TUNITAS CREEK BEACH IMPROVEMENTS PROJECT

**COUNTY PROJECT NO. P30T1
PROJECT FILE NO. E4995**

ADDENDUM NO. 1

The following **Addendum No. 1** to the above referenced project, dated April 21, 2023, shall be included in the project specifications and plans.

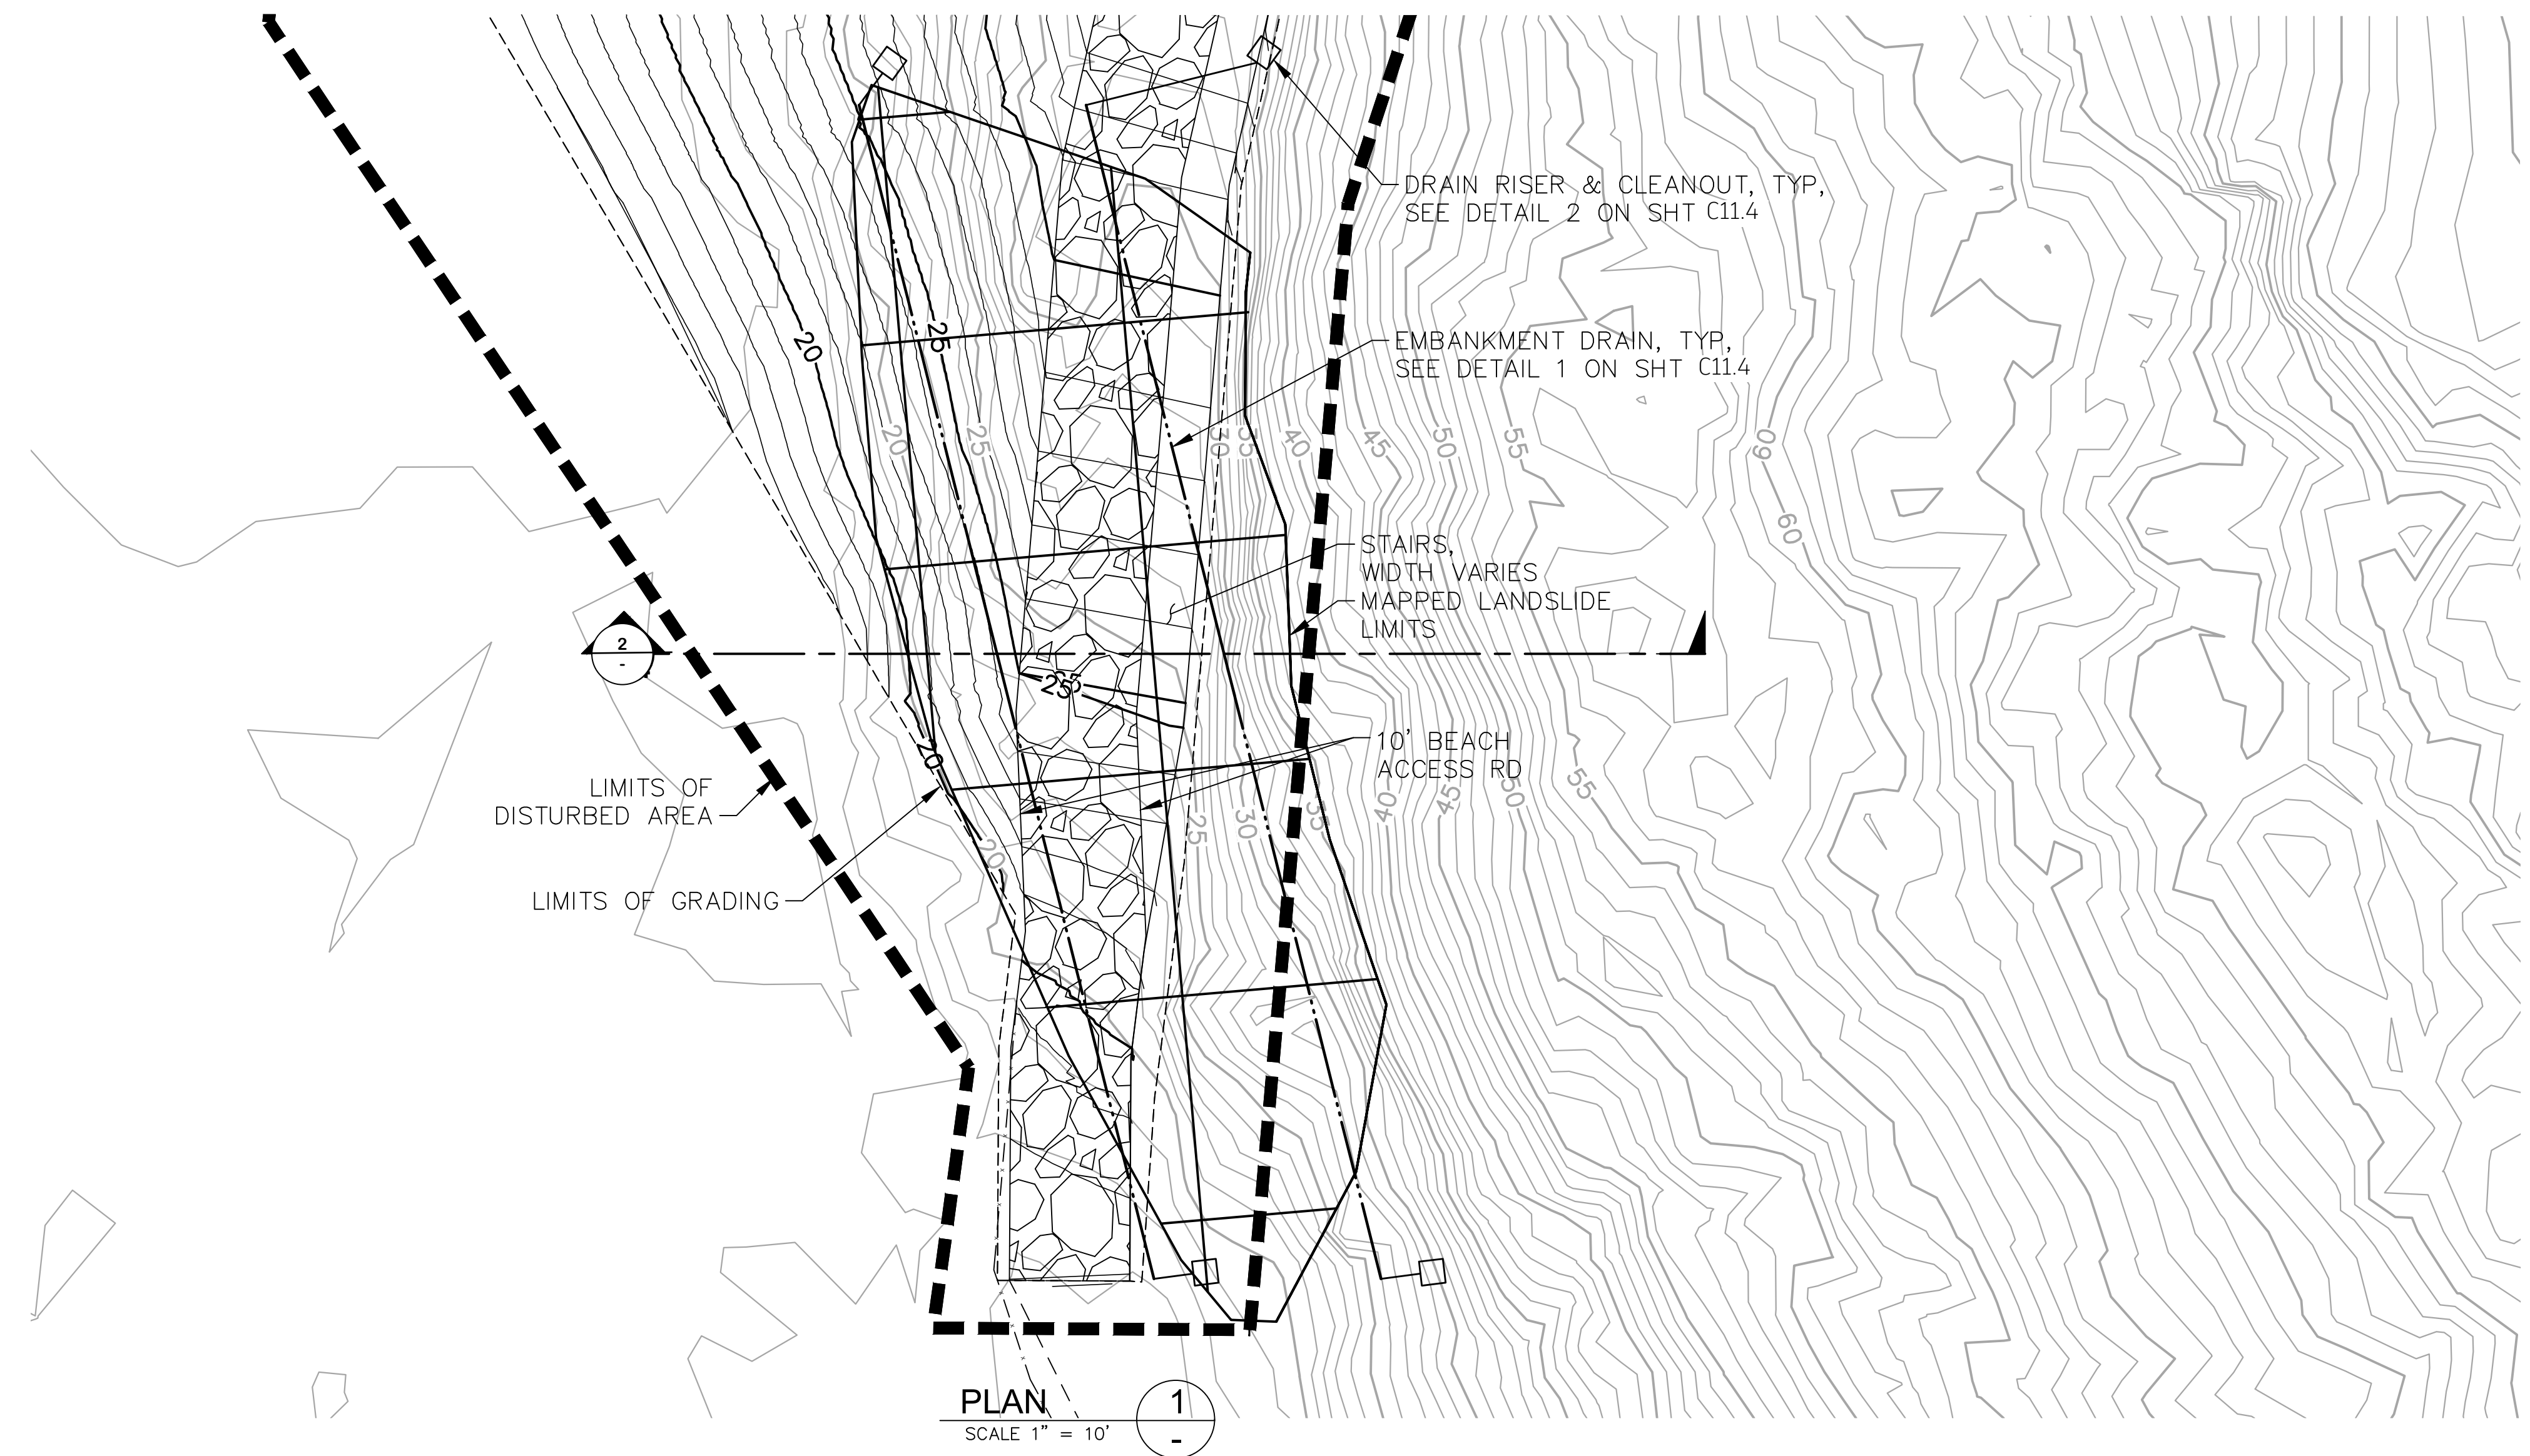
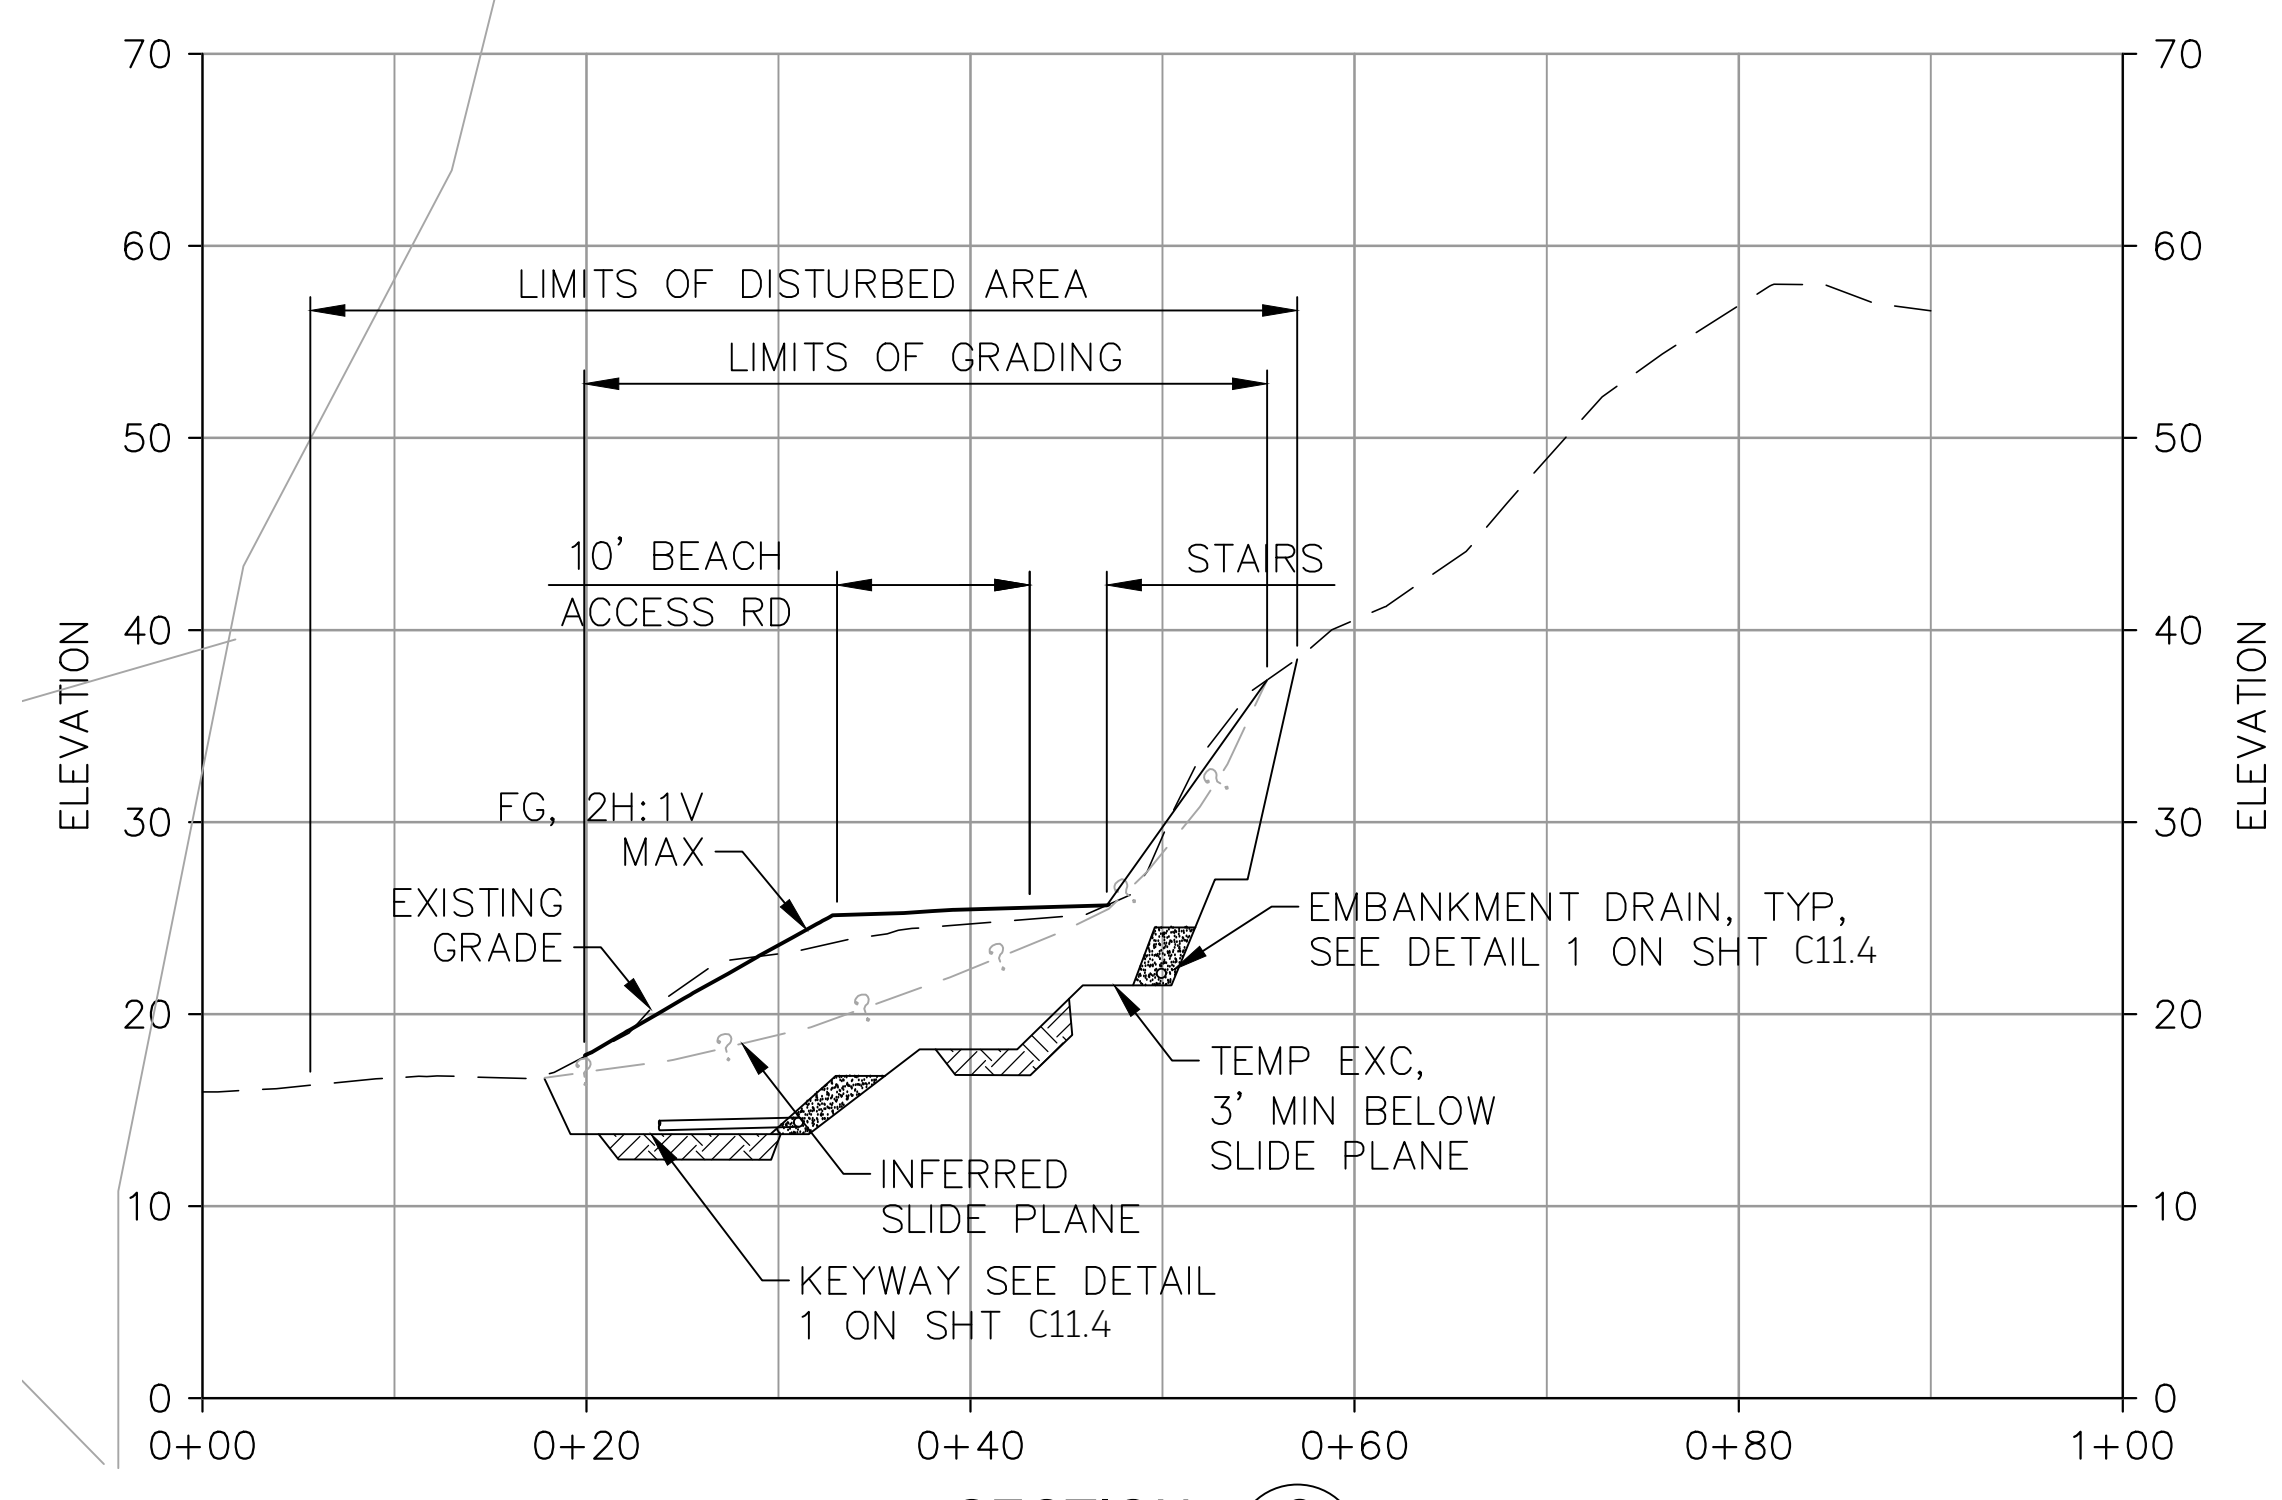
12. Note 3 of Plan Sheet C-11.1 through C-11.3 has been updated. Sheet C-11.1, Sheet C-11.2, and Sheet C11.3 shall be replaced in the Project Plans:

Replace Plan Sheet C-11.3 (Sheet 42 of 124) with Sheet C-11.3 (rev) (Sheet 42 of 124).

- EXCAVATION CONFIGURATION SHOWN IS PRELIMINARY. FINAL CONFIGURATION SHALL KEY ENGINEERED FILL 3 FEET INTO COMPETENT BEDROCK. THE DEPTH TO COMPETENT BEDROCK SHALL BE DETERMINED DURING CONSTRUCTION BY THE PROJECT GEOTECHNICAL ENGINEER OR GEOLOGIST.
- FACE OF KEYWAY TO BE EMBEDDED 3 FEET MINIMUM INTO COMPETENT BEDROCK ON THE DOWNHILL SIDE AS DETERMINED BY THE PROJECT GEOTECHNICAL ENGINEER OR GEOLOGIST.
- SEEPAGE ZONES ENCOUNTERED DURING EXCAVATION FOR THE LANDSLIDE MITIGATION SHALL BE EXCAVATED IN CONFORMANCE WITH NOTE 1 AND A SUBDRAIN INSTALLED AS OUTLINED ON DETAIL 1 ON SHEET C11.4 "EMBANKMENT DRAIN." ALL IDENTIFIED SEEPAGE ZONES SHALL RECEIVE 100 PERCENT COVERAGE OF A 2 FOOT THICK LAYER OF CALTRANS CLASS 2 PERMEABLE MATERIAL. THE PERFORATED SUBDRAIN PIPE SHALL BE CONNECTED TO THE SUBDRAIN OUTFALL SYSTEM.

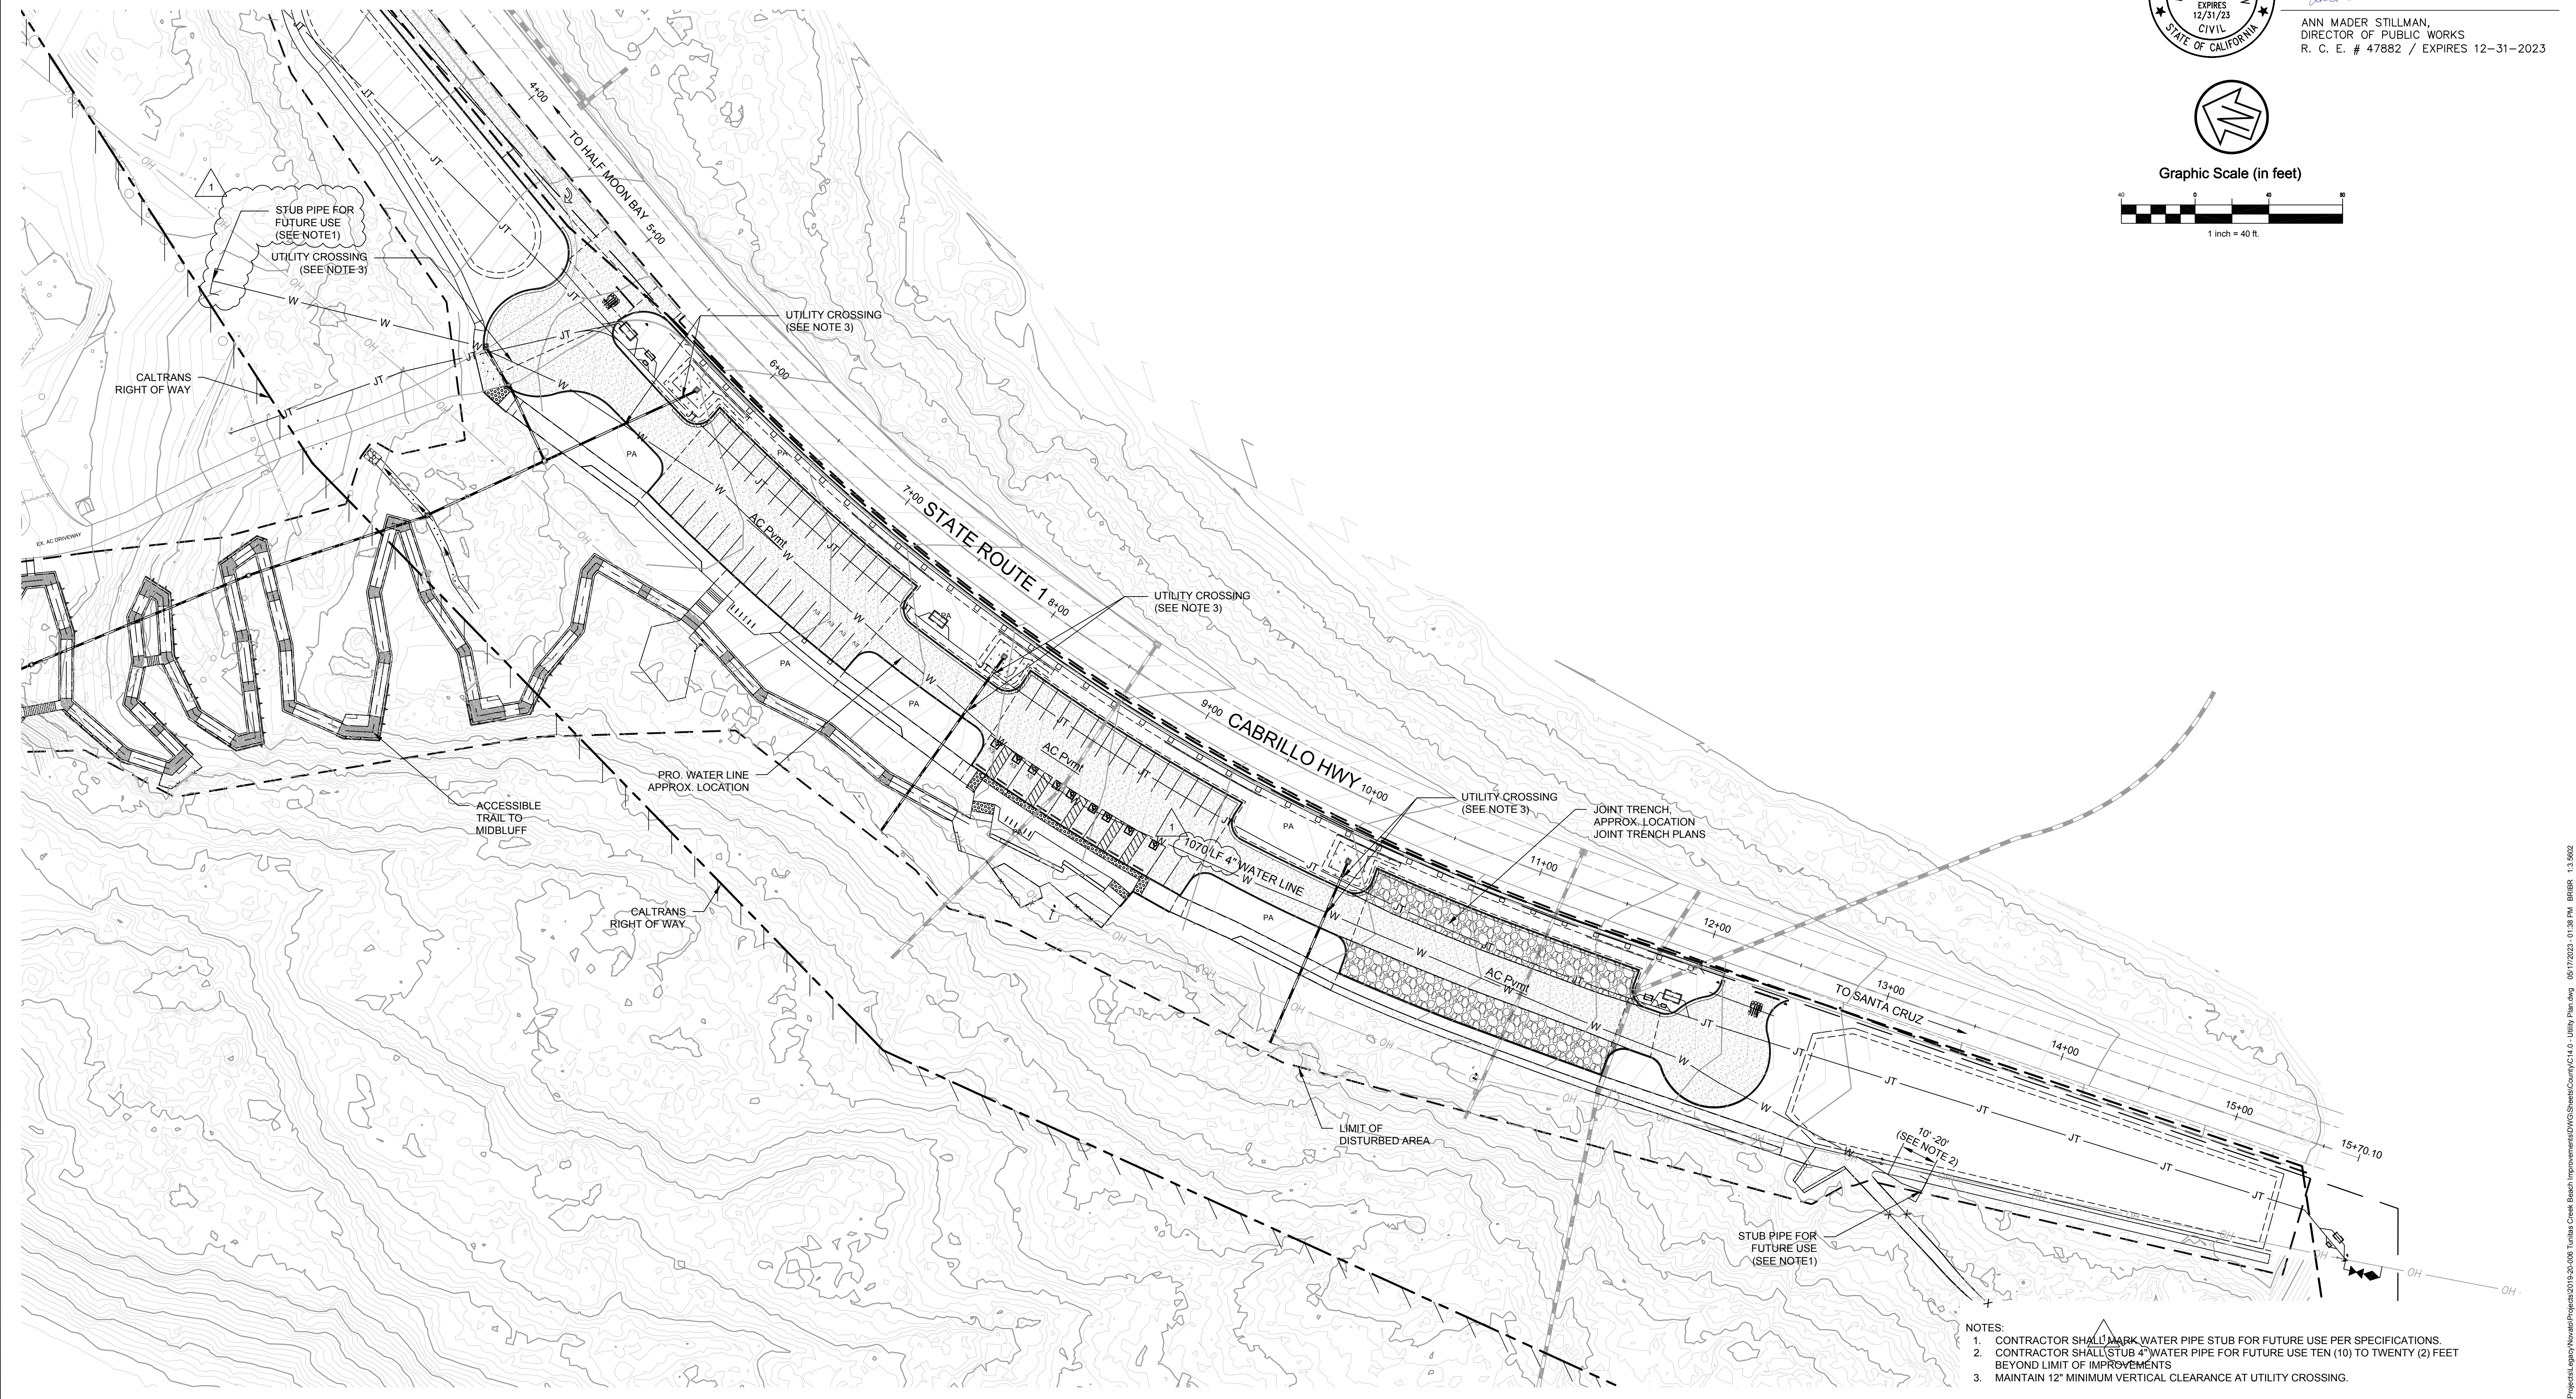
13. The waterline pipe size has been updated to 4 inches. Plan Sheet C-14 shall be replaced in the Project Plans:

Replace Plan Sheet C-14 (Sheet 49 of 124) with Sheet C-14 (rev) (Sheet 49 of 124).

- NOTES:
1. CONTRACTOR SHALL MARK WATER PIPE STUB FOR FUTURE USE PER SPECIFICATIONS.
 2. CONTRACTOR SHALL STUB 4" WATER PIPE FOR FUTURE USE TEN (10) TO TWENTY (2) FEET BEYOND LIMIT OF IMPROVEMENTS
 3. MAINTAIN 12" MINIMUM VERTICAL CLEARANCE AT UTILITY CROSSING.
